Landscape Assessment:

Observations and Revitalization Recommendations

Kalele Kai Condominiums

January 22, 2015

Building 1 Entry (L)

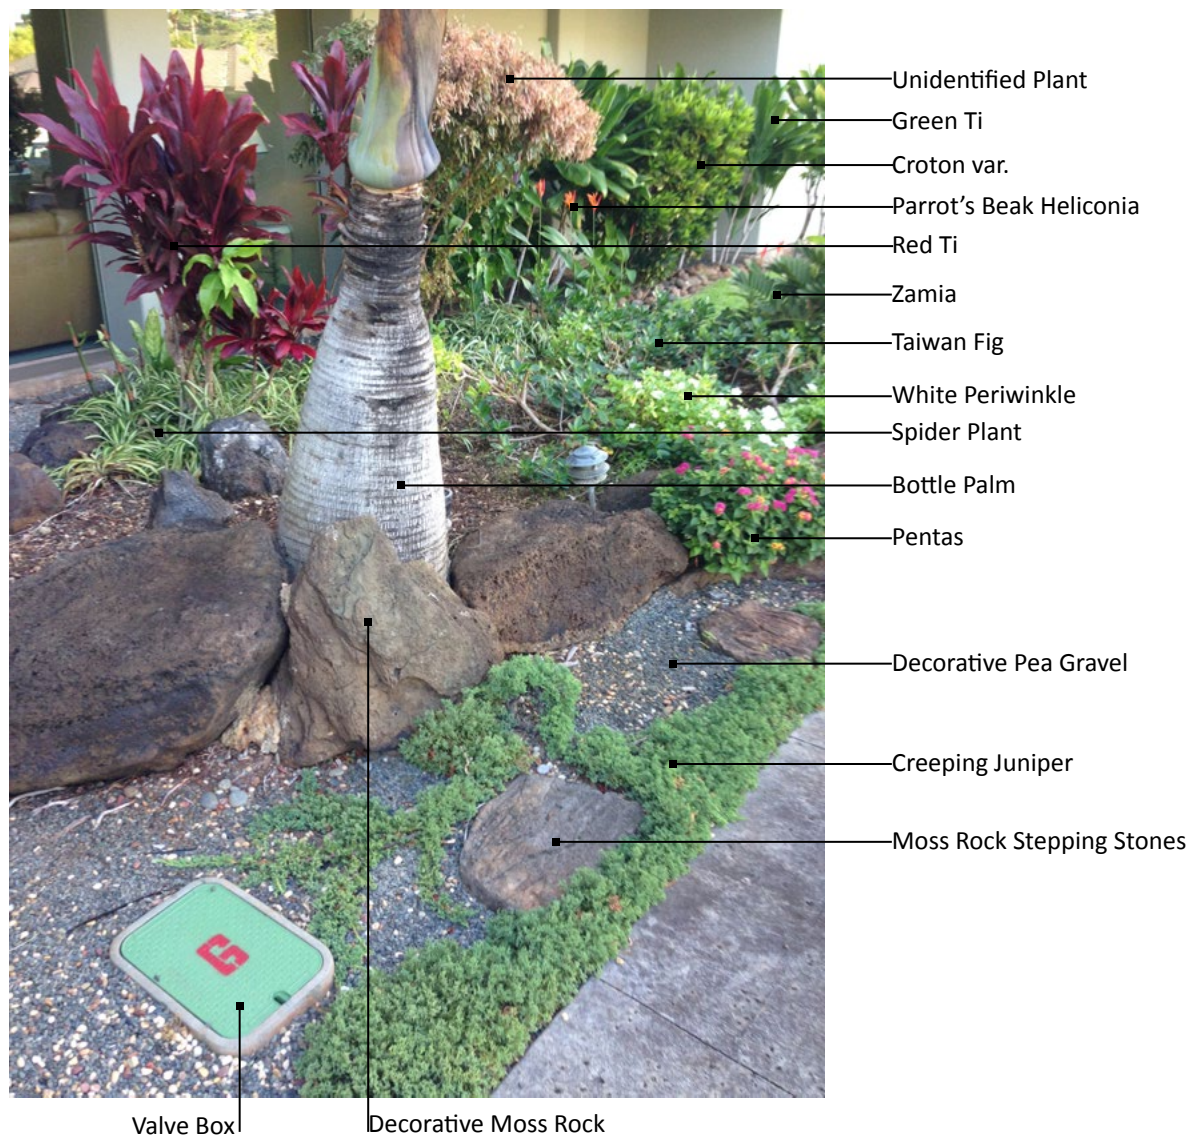
The general composition of the planting spaces are good. The moss rock placement allows an elevated area along the wall creating a terraced effect. The varied sizes of the moss rock help to convey a more “natural effect.” The layout location of the boulders also act as a containment for planting and may also allow for better percolation and drainage. With the acceptance of the “seasonal” placement of the Poinsettia, there are approximately 7+ different species of plants in about a 100sf area. The planting seems to reflect different “cultural themes” and planting “trends.” i.e. Japanese/Topical and Old Fashioned/Contemporary. The decorative pea gravel and decorative tile pavers at the entry also differ from the other two building entries. This entry has the most “robust” appearance of the three.

Reducing the number of species would help to “calm” the presentation of the entry. The moss rock boulders could remain in place as-is. Also selecting plants of a consistent palette would also help to appease the eye. For example, if the design intent is to be “Japanese” then all plants of the pallets should be of that “style” or visual quality. The decorative multi-colored pea gravel can appear a bit “messy” due to the small texture and multi-color. The river rock as the other entries have may be a good alternative.

Building 2 Entry (L)

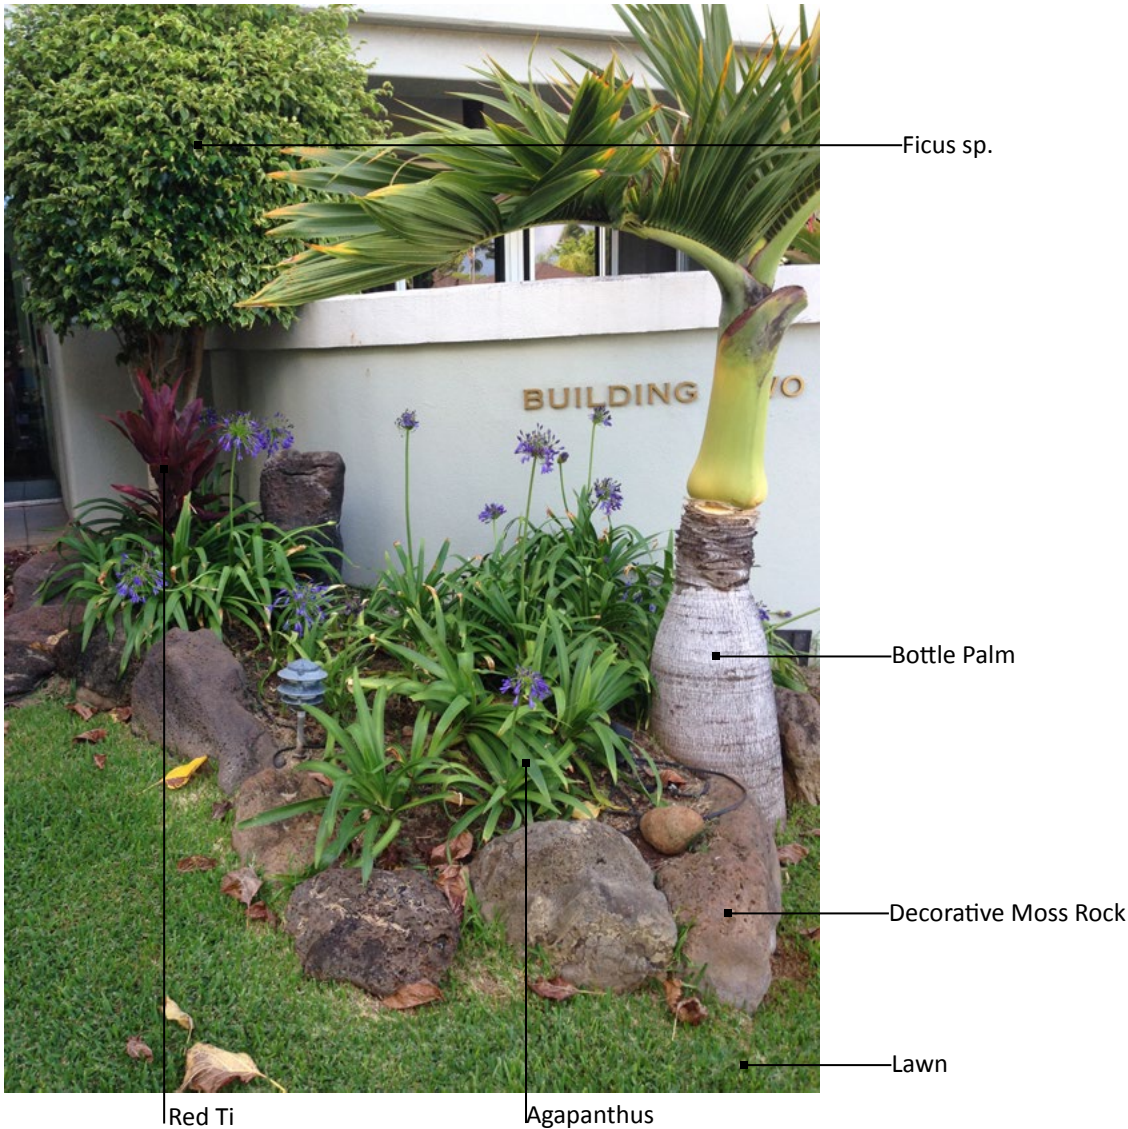
This area takes a minimalist “zen garden” approach. A simple “river” of pebbles in lawn though lacking in dimension, texture and color. The “Japanese” bridge and lantern appear kitschy and out of place at their locations and the plastic header has an unflattering effect to the “river” concept. Small irregular lawn areas make for tedious maintenance.

Add moss rock boulders for a raised planting area similar to opposing side and other building entries. Incorporate small shrubs and ground covers will add dimension, texture and color which will eliminate the need for frequent grass trimming. Changing pavers at the entry would update the look and feel and provide a warmer more appealing “welcome mat” to the doorway.
